Technical Service Bulletin

01 Charge air pressure pipe for turbocharger / cut-off valve - oil residue - 4 cyl. 2.0 TFSI

01 23 67 2071200/1 August 10, 2023.

Model(s)	Year	VIN Range	Vehicle-Specific Equipment
S3	2022 – 2023	All	Not Applicable

Figure 2: Charge air pressure pipe.

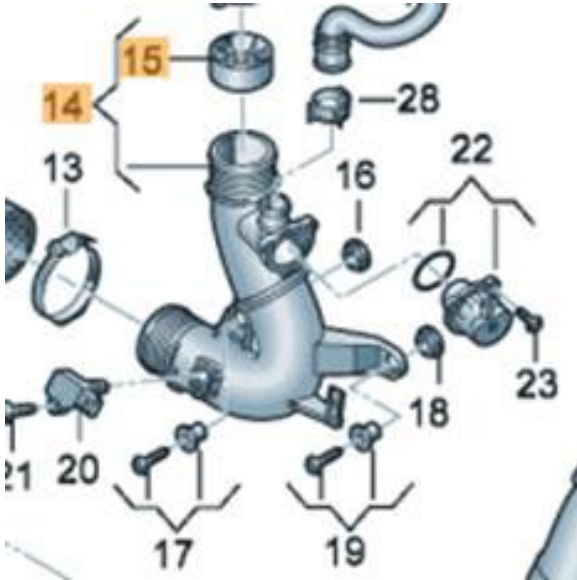
- Oil residue on the sealing point between charge air pressure pipe and cut-off valve, see figure 1.

Leak at connection between charge air pressure pipe and cut-off valve.

Improved calendar week 24, 2022.

- Replace the charge air pressure pipe according to ETKA (figure 2, item 14).
- Replacing the cut-off valve, item 22, is not required.
